PLANNED UNIT DEVELOPMENT**Date: December 17, 2009****DEVELOPMENT NAME**

DBM Company, LP

LOCATION1234 & 1248 Hillcrest Road
(Northwest corner of Hillcrest Road and Grelot Road)**CITY COUNCIL
DISTRICT**

Planned Unit Development Approval to allow shared access between two building sites.

SITE PLAN

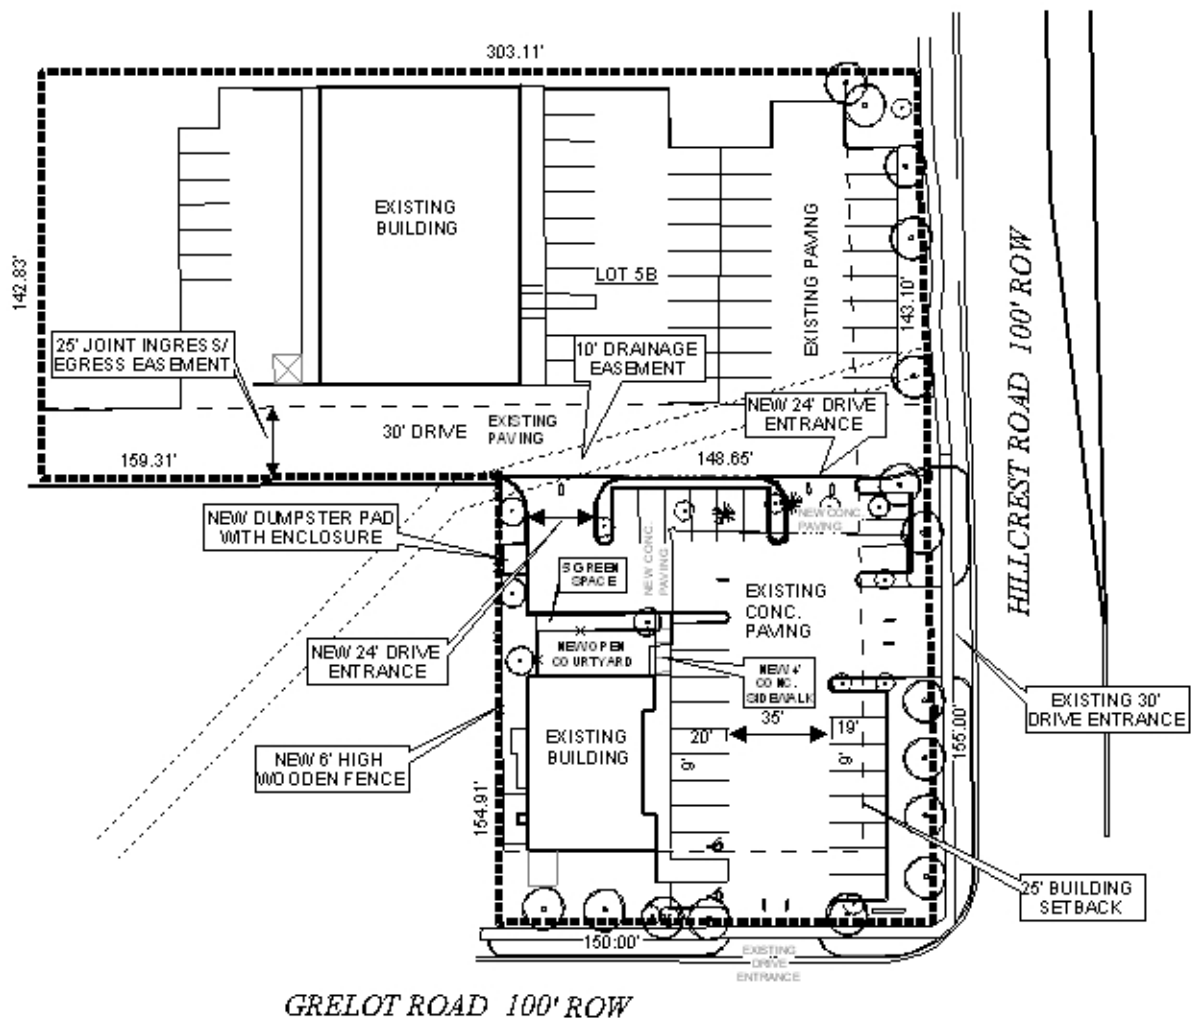
It should be noted that, while the applicant's proposal may be minor and desired, one issue must be addressed. As illustrated on the site plan, there is an existing 25' joint ingress/egress easement providing access to the property to the West of the subject site; shared access that was approved in 2006 via Planned Unit Development. Before this application can be approved, all properties sharing access must be included.

As mentioned, all proposed work is mainly limited to the Southernmost lot, which has one existing curb cut to both Hillcrest and Grelot Roads. As illustrated on the site plan, the applicant is proposing two additional curb cuts to the joint ingress/egress easement. As both Hillcrest and Grelot Roads are major streets, access management is of great concern. With that said, Planning and Traffic Engineering staff feel that the proposed number of curb cuts is extreme. At a minimum, the existing curb cut to Hillcrest Road should be removed; ideally, the Eastern curb cut to the joint ingress/egress easement should also be removed in order to provide the safest and most efficient circulation of traffic. Additionally, the applicant has not accurately delineated the existing curb cut onto Hillcrest Road for the ingress/egress easement; this should also be addressed.

It should also be noted that the proposed configuration of curb cuts will require the removal of several "protected" trees. While, the site plan appears to illustrate compliance, a new thorough review will be required at the time of permitting. Furthermore, per comments from Urban Forestry, the lot to the North should also be brought into full compliance.

It appears that proposed dumpster location is approximately one (1) foot from the West property line. Section 64-3.E.3 of the Zoning Ordinance requires a side yard setback of zero (0) **OR** five (5) feet for sites within a B-3, Community Business District; the applicant should revise the site plan accordingly.

On a minor note, the site plan illustrates the Northern property as Lot 5-A, contrary to the associated recorded plat. It should be revised to read Lot 5-B.

- 1) Inclusion of all properties sharing access via the joint ingress/egress easement, along with the submittal of additional fees and mailing labels;
- 2) Elimination of both the Eastern curb cut onto the shared ingress/egress easement and the existing curb cut to Hillcrest Road (on the Southernmost lot);
- 3) Revision of the site plan to accurately delineate the existing curb cut onto Hillcrest Road for the joint ingress/egress easement;
- 4) Revision of the dumpster location to comply with Section 64-3.E.3 of the Zoning Ordinance; and
- 5) Revision of the site plan to label the Northern property as Lot 5-B, instead of 5-A.

SITE PLAN ILLUSTRATING STAFF PROPOSAL

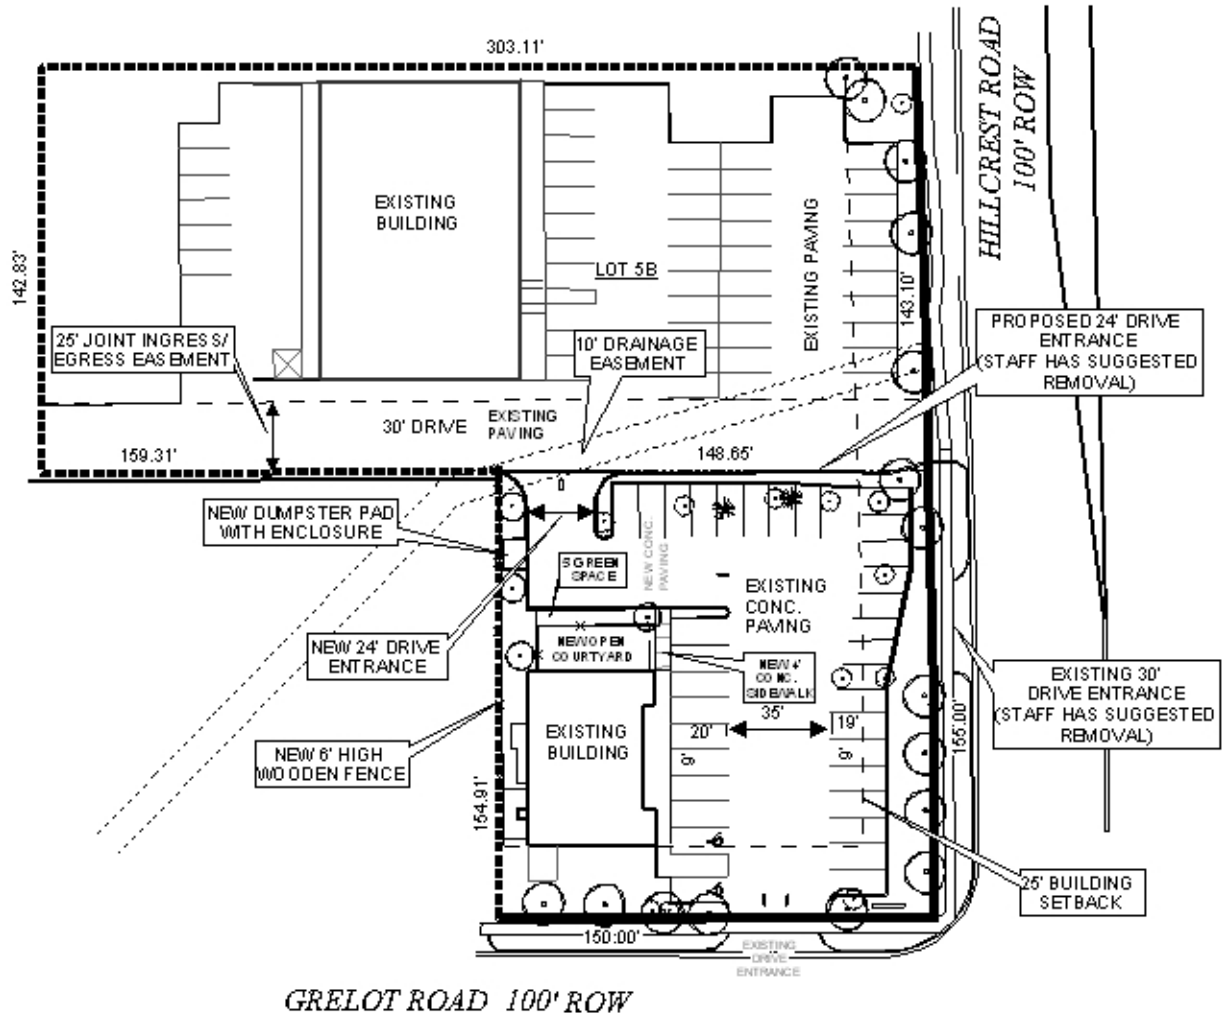
Driveway number, size, location, and design to be approved by Traffic Engineering and conform to AASHTO standards. To improve access to Hillcrest Road and to eliminate on site circulation conflicts the driveway accessing Hillcrest Road from the site should be closed and the eastern most driveway access the easement should be eliminated.
